Access Compliance Report

Public Rights-of-Way

(Curb Ramps)

Intersection ID: 7478	Main Street: STONEHURST_DR	Cross Street: SULLINS_RD	Location:	N/A
ADA ID: D71CF0619445	Ramp Type: Perp	Initial Pass/Fail: Fail	Overall Compliance: No	Severity Score: 12.5
Codes/Mitigation Info/Possible Solution		Field Measurements/Component Compliance

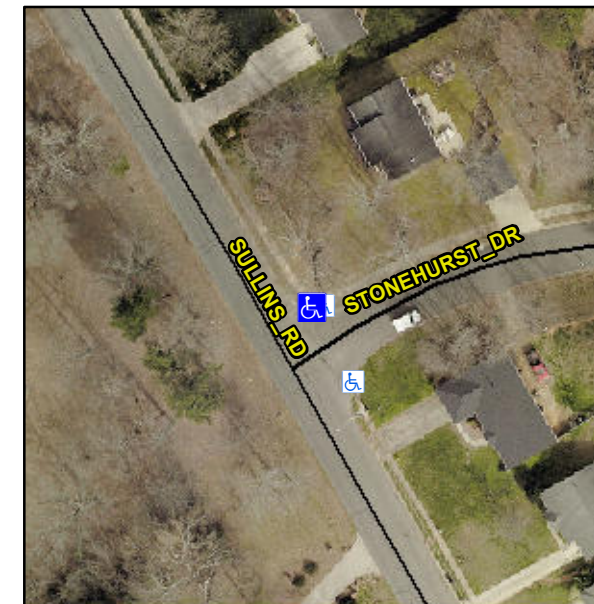
Not Found, R304.2.2

Compliance	Description	Data	Compliance	Description	Data
N/A	Ramp Length (in)	48.0	No	Ramp Slope (%)	9.4
Yes	Ramp Width (in)	48.0	Yes	Ramp XSlope (%)	1.6
N/A	Flare Type LT	N/A	N/A	Flare Type RT	N/A
N/A	Flare Slope LT (%)	N/A	N/A	Flare Slope RT (%)	N/A
N/A	Flare Traversable LT?	N/A	N/A	Flare Traversable RT?	N/A
N/A	Landing Length (in)	N/A	N/A	DWS Provided?	N/A
N/A	Landing Width (in)	N/A	N/A	DWS Contrast?	N/A
N/A	Landing Slope (%)	N/A	N/A	DWS Length (in)	N/A
N/A	Landing X Slope (%)	N/A	N/A	DWS Full Width?	N/A
N/A	Landing Curb? (Y/N)	N/A	N/A	DWS Offset (in)	N/A
N/A	Shared Landing?	N/A			
N/A	Gutter Ponding?	N/A	N/A	Gutter Slope (%)	N/A
N/A	Gutter Lip Ht (in)	N/A	N/A	Gutter X Slope (%)	N/A
N/A	Painted X Walk1?	No	N/A	Painted X Walk2?	N/A
	X Walk 1 Direction	To S		X Walk 2 Direction	N/A
N/A	X Walk 1 Width (in)	N/A	N/A	X Walk 2 Width (in)	N/A
	X Walk 1 Slope (%)	1.8		X Walk 2 Slope (%)	N/A
	X Walk 1 X Slope (%)	1.9		X Walk 2 X Slope (%)	N/A

Remove & Replace Entire Ramp.
